**APA General
Permit/Order
2024G-1**

Permit #: 2026-0166A

**Certificate for Certain Minor
Regulated Activities in APA
Jurisdictional Freshwater Wetlands**

**TLD Line 884
Essex County, New York**

Attachment 2: Stream Air Bridge Specification

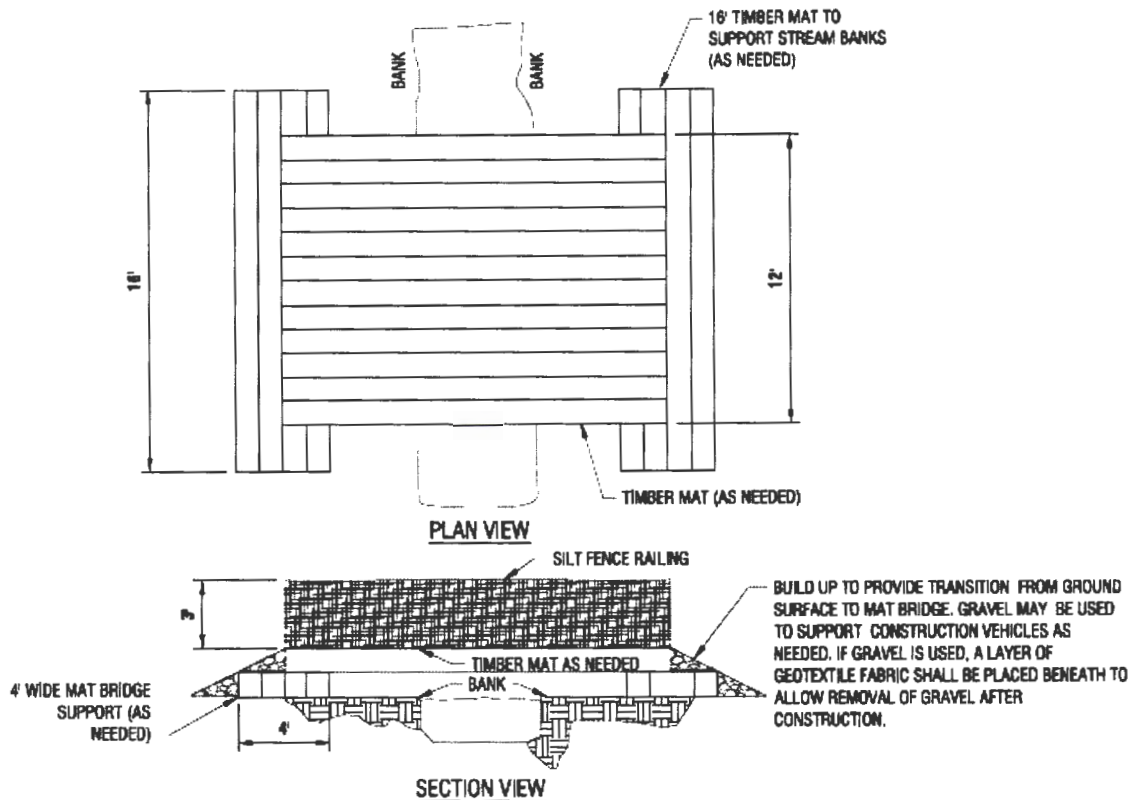
1. INSTALL IN ACCORDANCE WITH "TEMPORARY ACCESS WATERWAY CROSSING" (BLUE BOOK).
2. USE ADDITIONAL EROSION CONTROLS AS NEEDED TO MINIMIZE EROSION.
3. PERFORM ROUTINE INSPECTION TO INCLUDE REMOVAL OF LOOSE SOIL TRACKED ONTO BRIDGE BY EQUIPMENT. INSPECT STREAM BANKS FOR STABILITY.
4. MATS SHALL BE POSITIONED TO MAINTAIN THE NATURAL STREAM CHARACTERISTICS.
5. BRIDGES USED FOR MULTIPLE CROSSINGS AND LONG TERM USE SHALL BE INSTALLED WITH FABRIC, SECONDARY DECKING, AND SIDE BOARDS.
6. INSTALL SILT FENCE RAILING ALONG THE SIDES OF BRIDGE.
